ADDENDUM NO. 2

February 23, 2022

**DOUGLAS MACARTHUR ELEMENTARY SCHOOL ADDITIONS,
RENOVATIONS, AND RELATED WORK
Crown Point, IN 46307**

This Addendum consists of Pages ADD 2-1 through ADD 2-2 and attached Addendum No. 2 from Gibraltar Design dated February 21, 2022 and consisting of 7 pages, Specification Section 12 25 00 - Roller Shades and 52 drawings.

ALUMINUM STOREFRONT ELEVATIONS (SF)

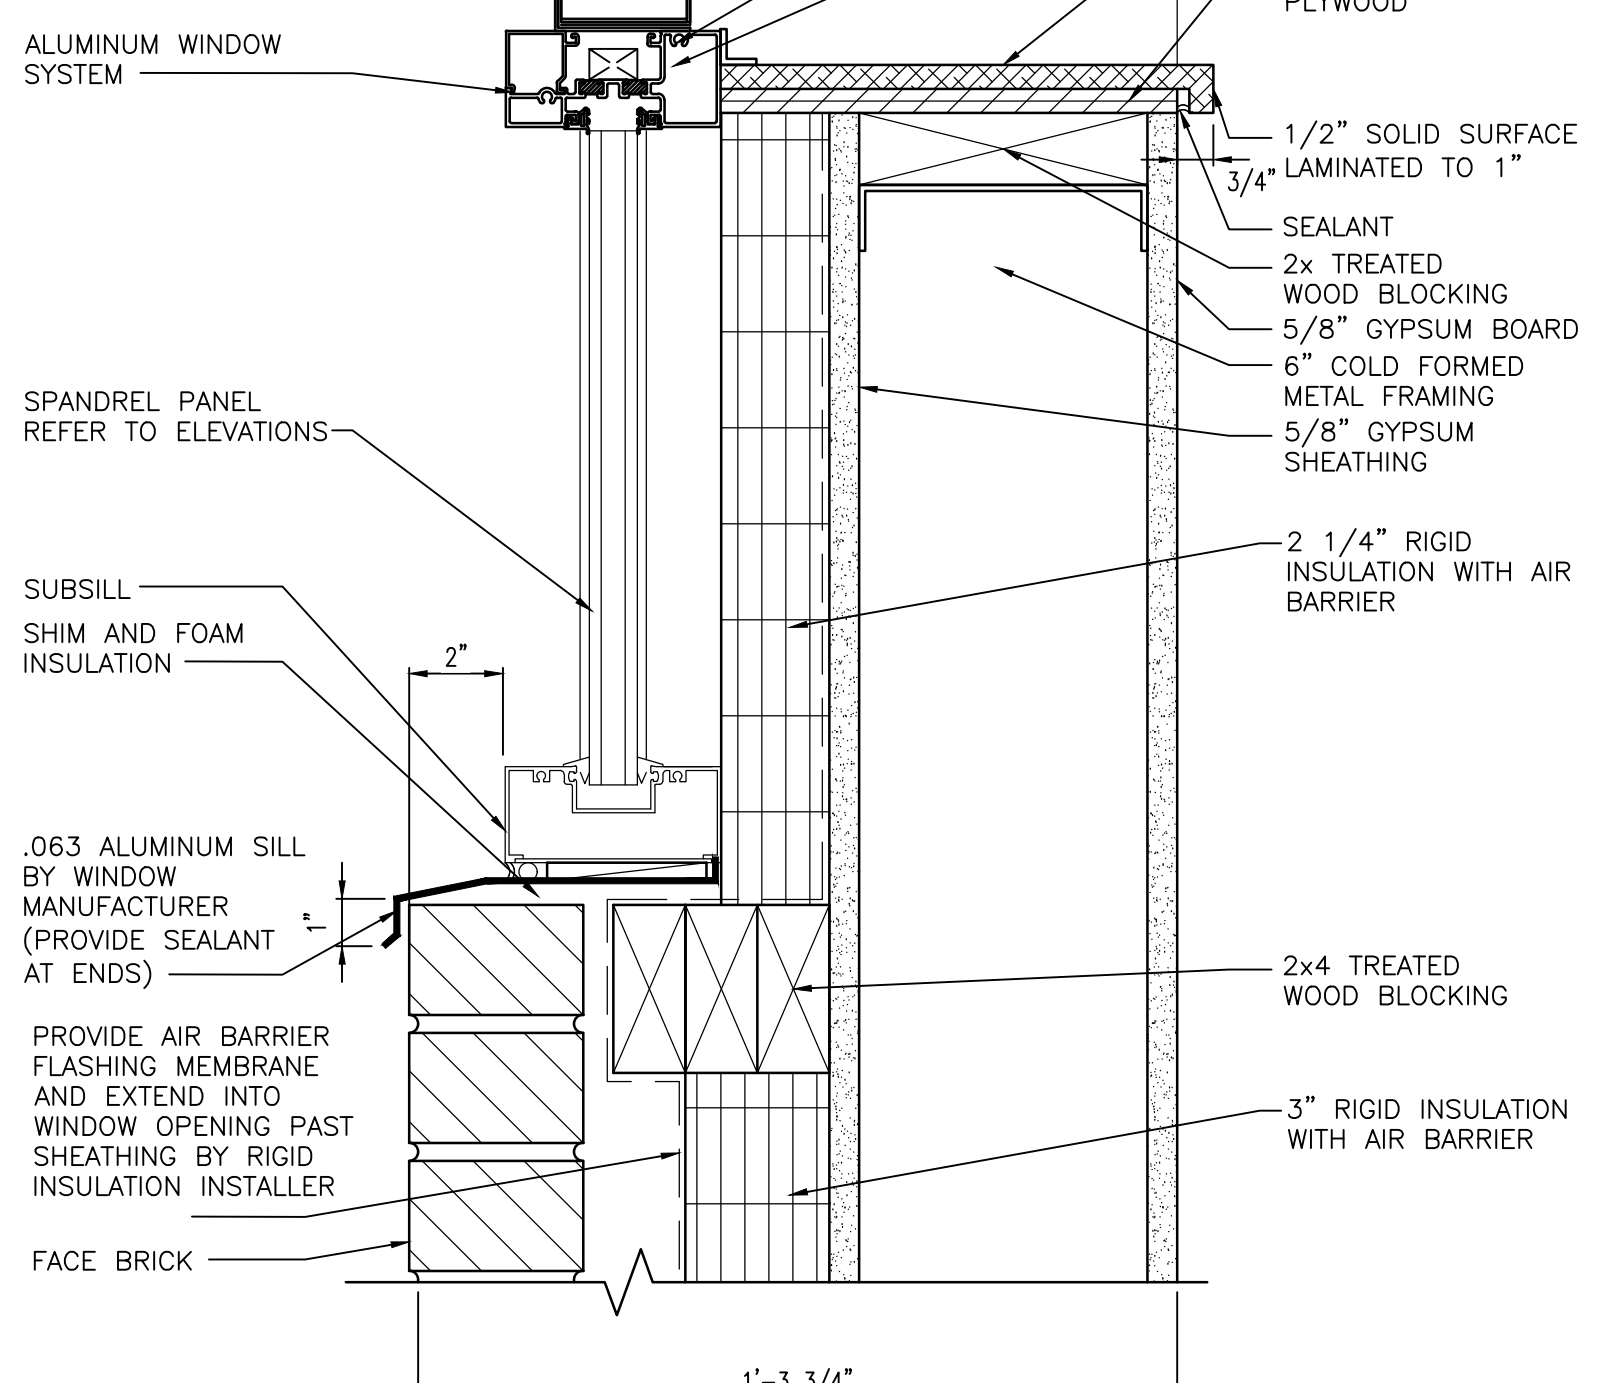
- A. Refer to revised, full size drawing, included in this Addendum, for the following revisions:
 - 1. Revise Aluminum Storefront Elevations (SF) 1/A-620.

Thursday, 2/17/2022 - 10:40 AM - LAST SAVED BY: EMOORE, J.
Y:\21-113 CROWN POINT CSC - MACARTHUR ES ADDITION
AND RENOVATIONS\21-113 DRAWINGS\05 ARCH\A-862.DWG

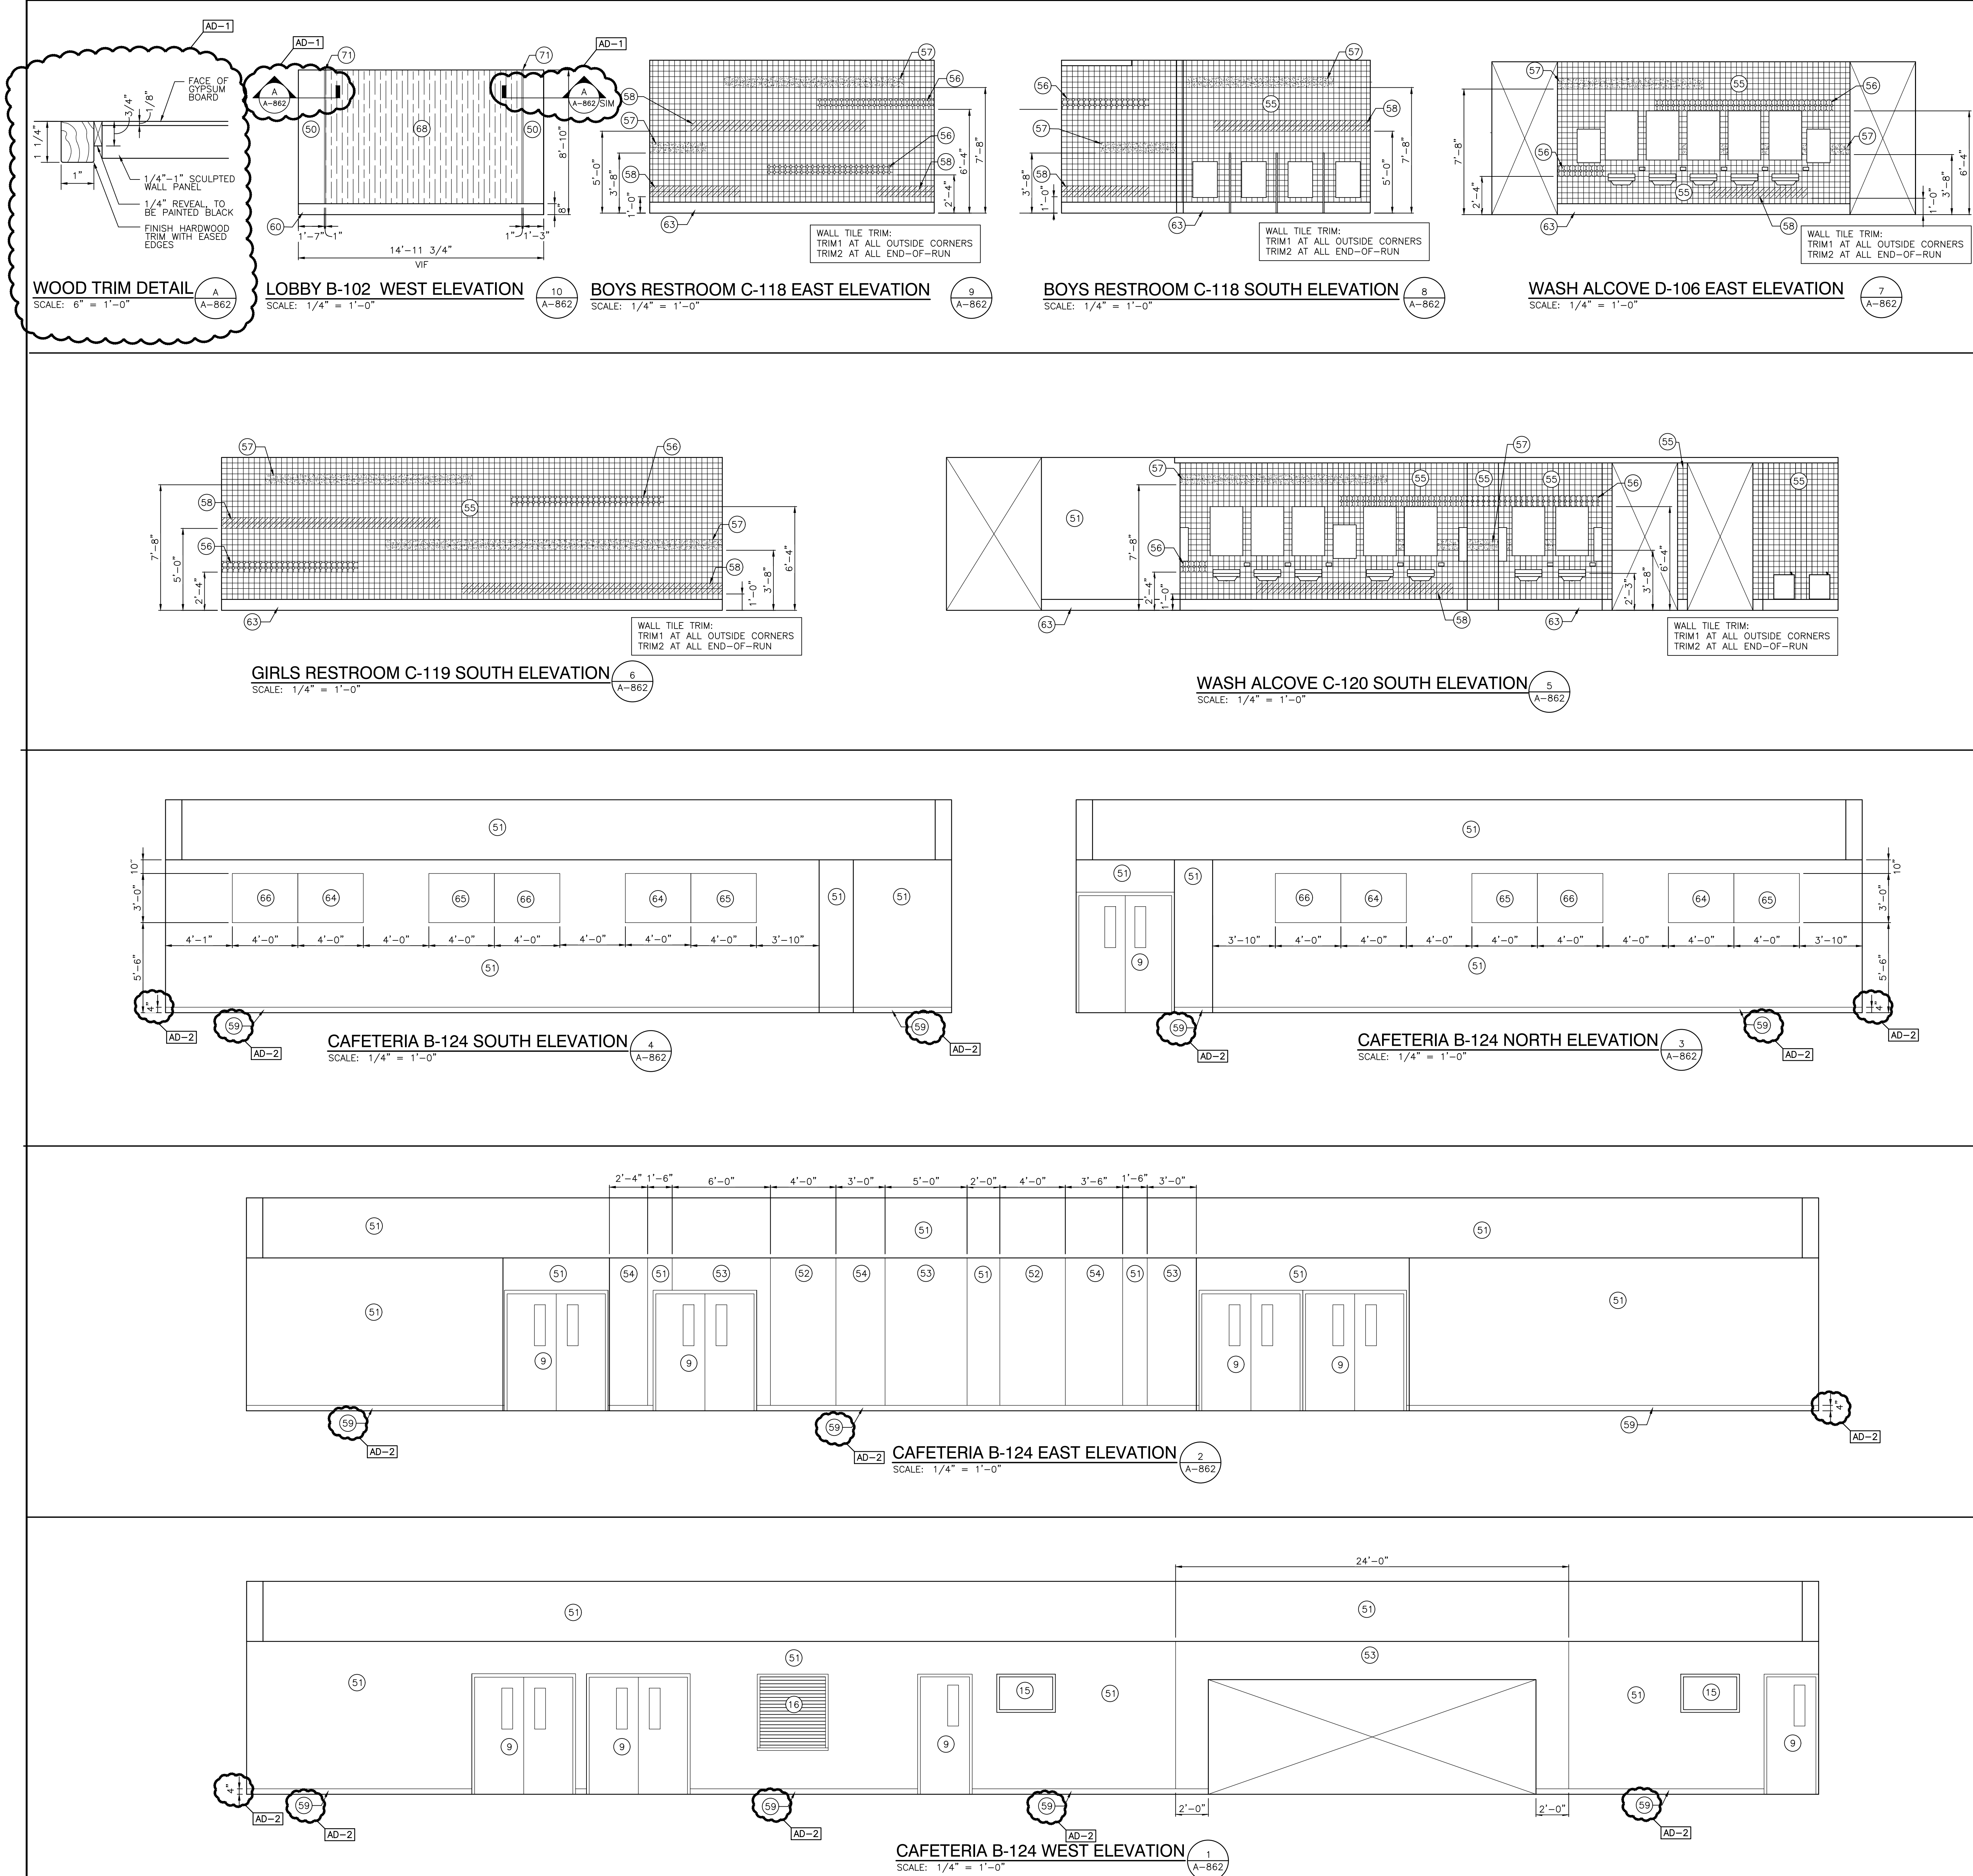
- A. Refer to revised, full size drawing, included in this Addendum, for the following revisions:
 - 1. Revise Keynote 59 text.
 - 2. Addition of wall base dimensions, as noted.
 - 3. Revision of wall base Keynotes, as noted.

A-863

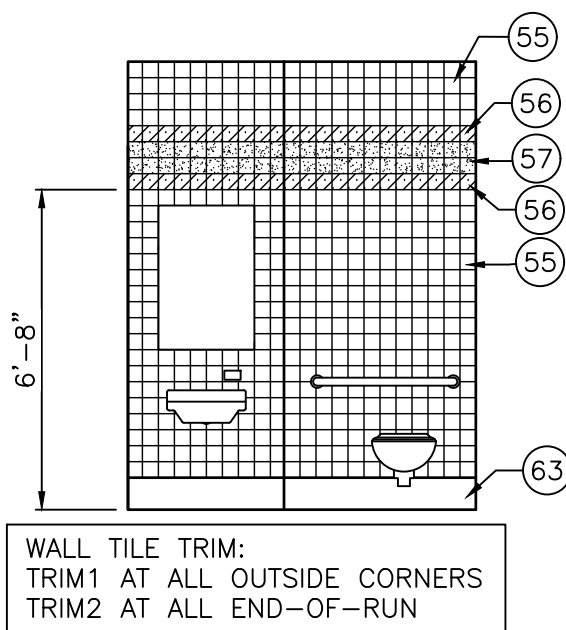
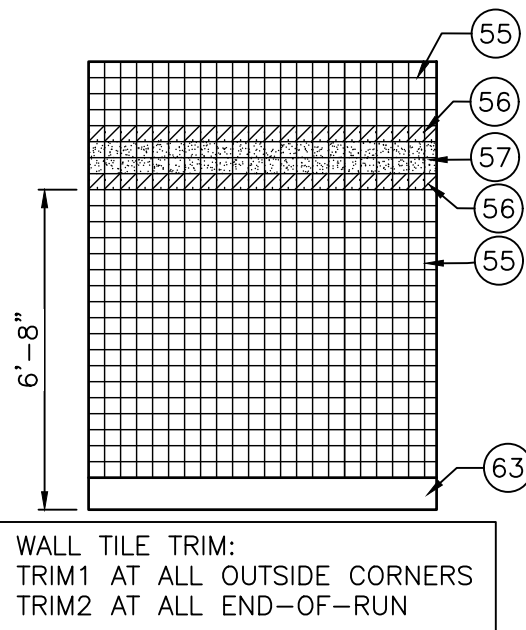
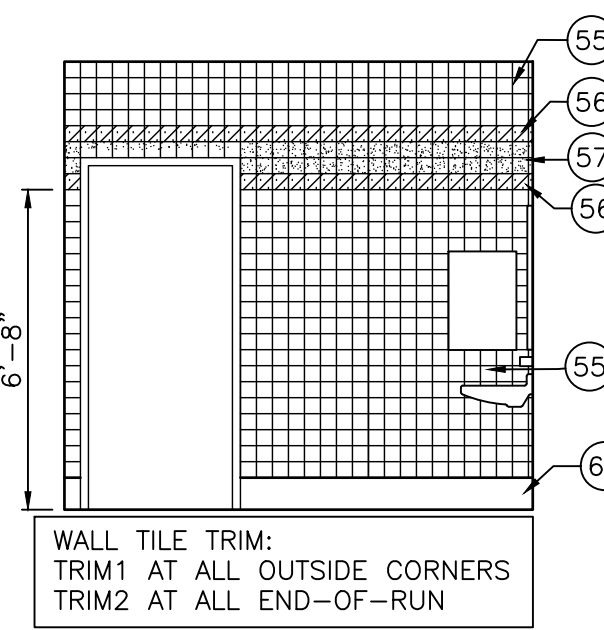
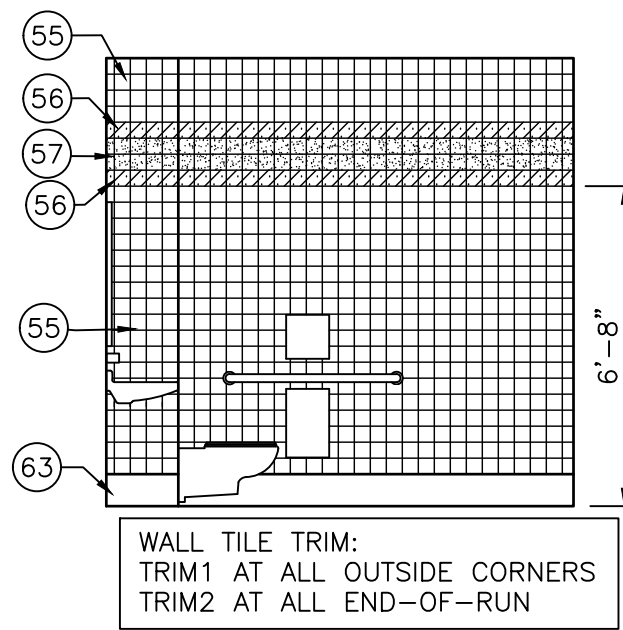
- A. Refer to revised, full size drawing, included in this Addendum, for the following revisions:
 - 1. Revise Keynote 59 text.
 - 2. Remove elevation 5/A-863 in its entirety.

A-903

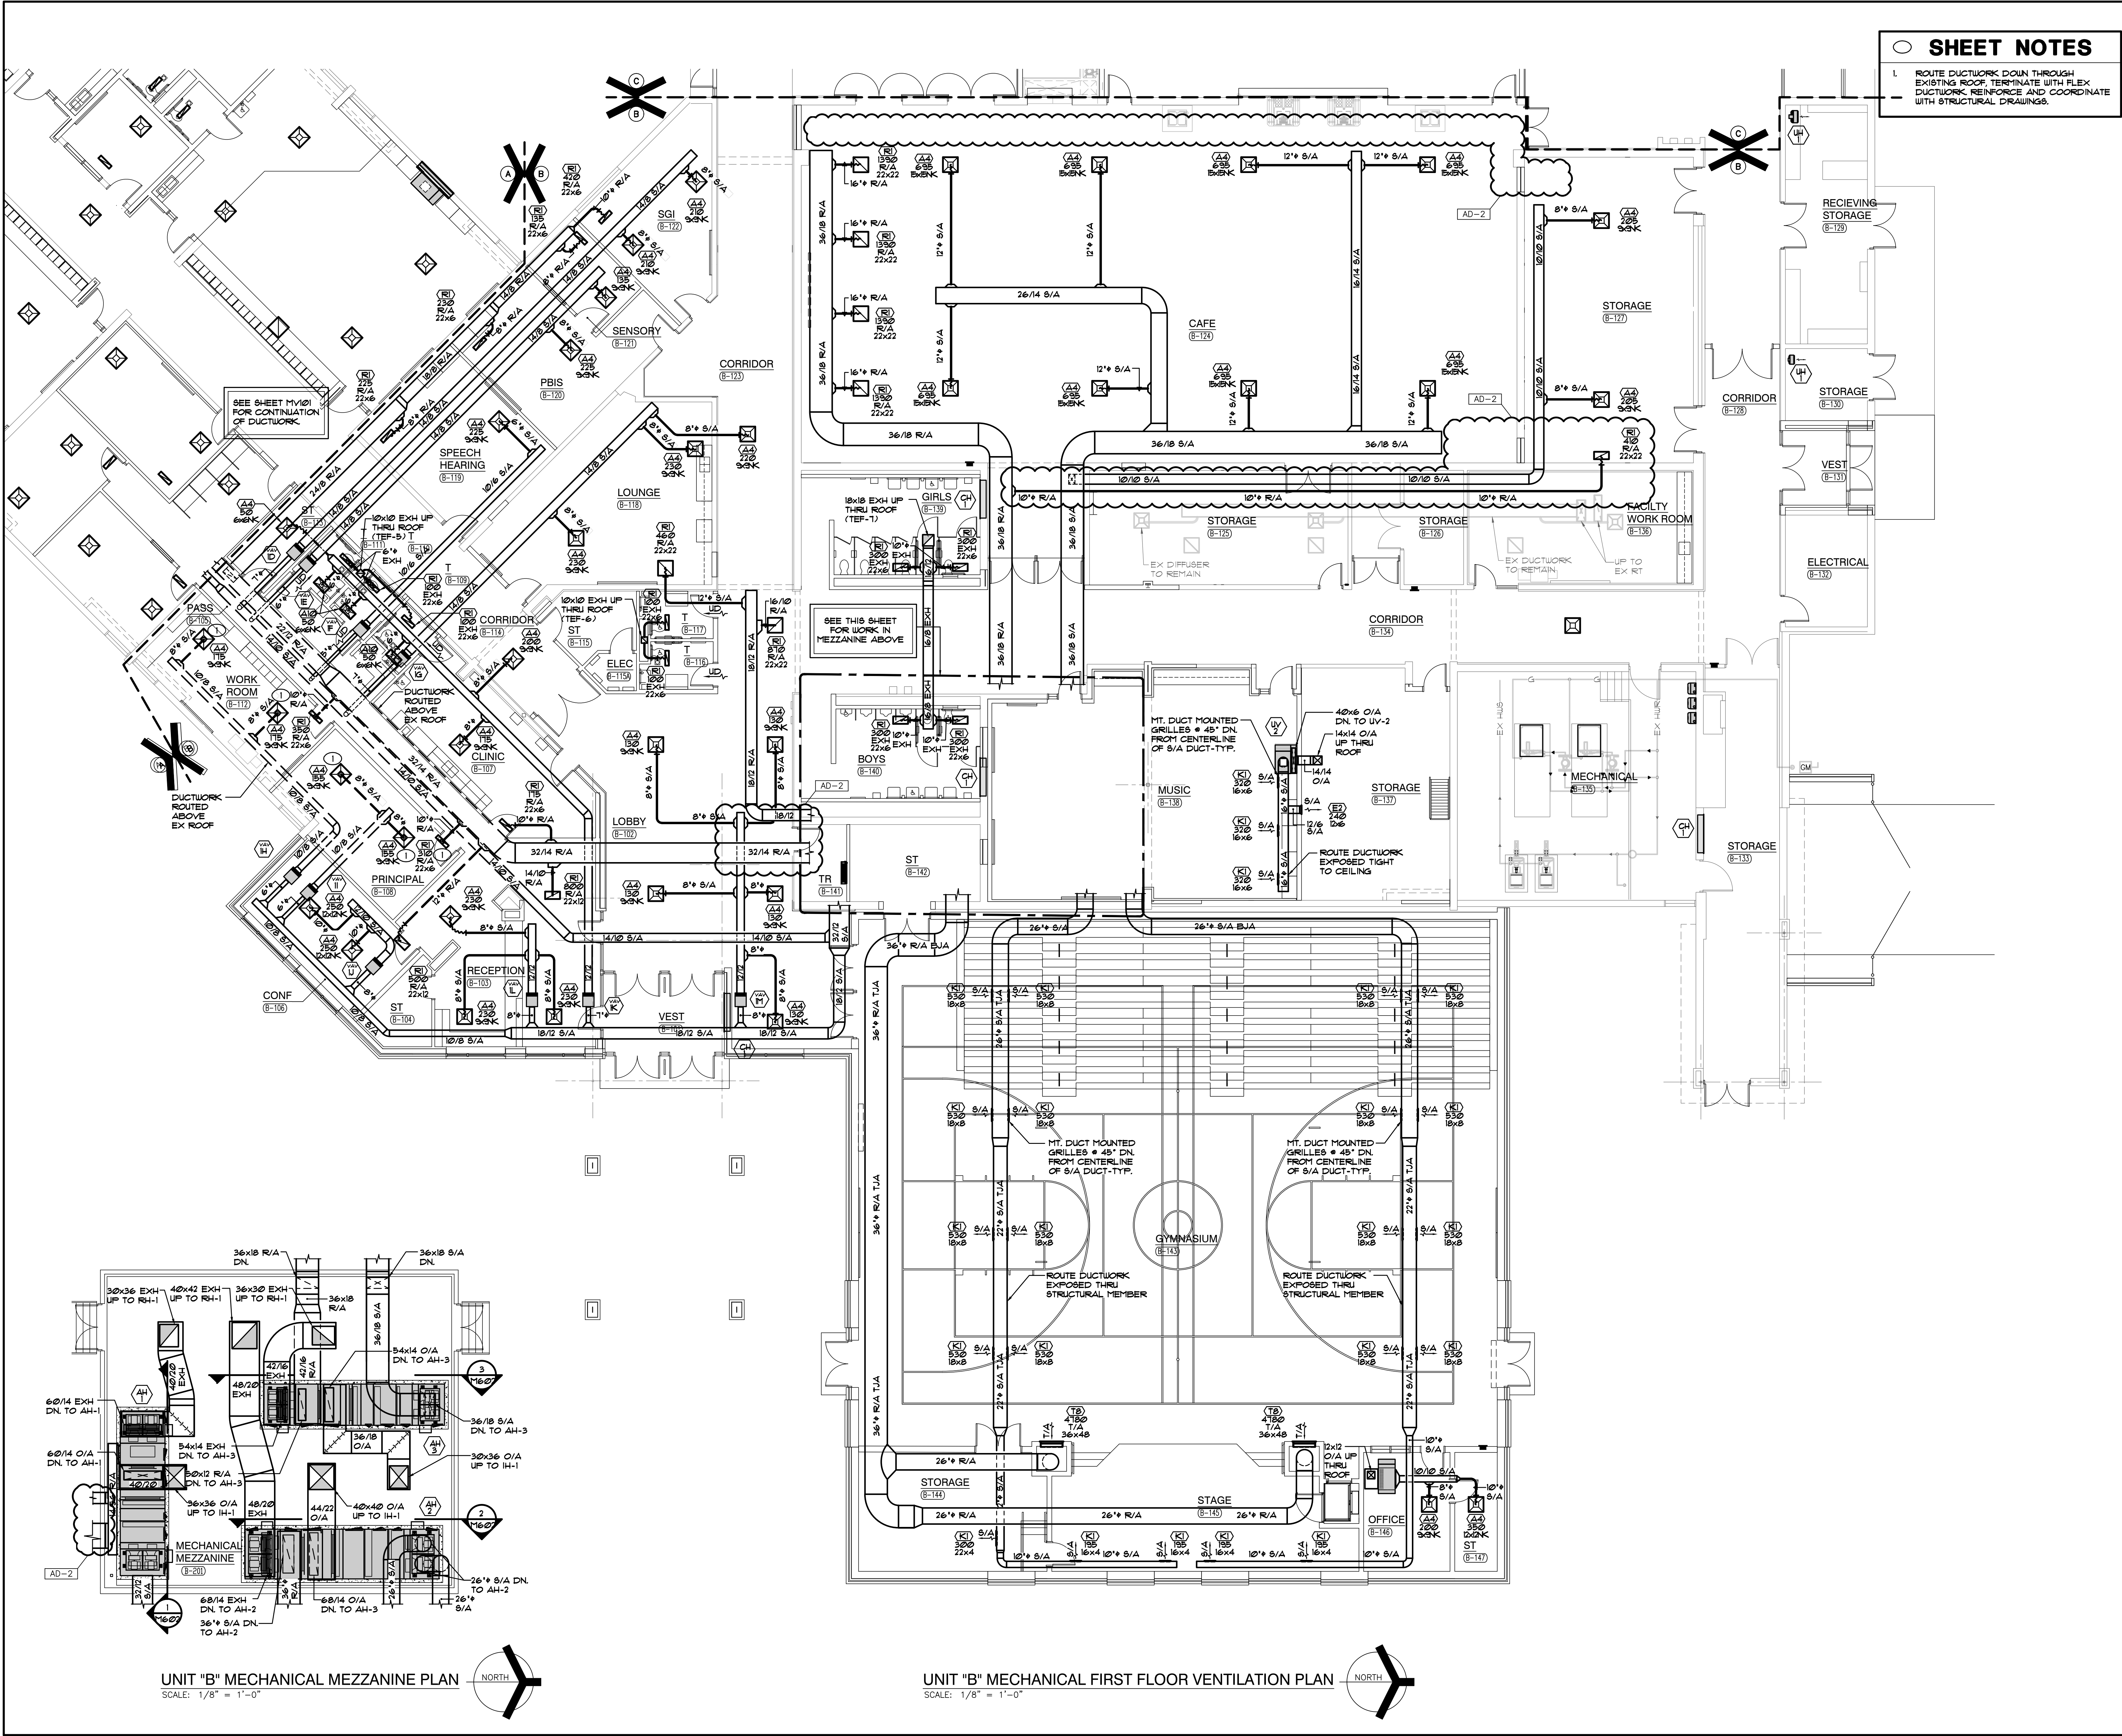
- A. Refer to revised, full size drawing, included in this Addendum, for the following revisions:
 - 1. Revise Lighting Layout in Serving C-132
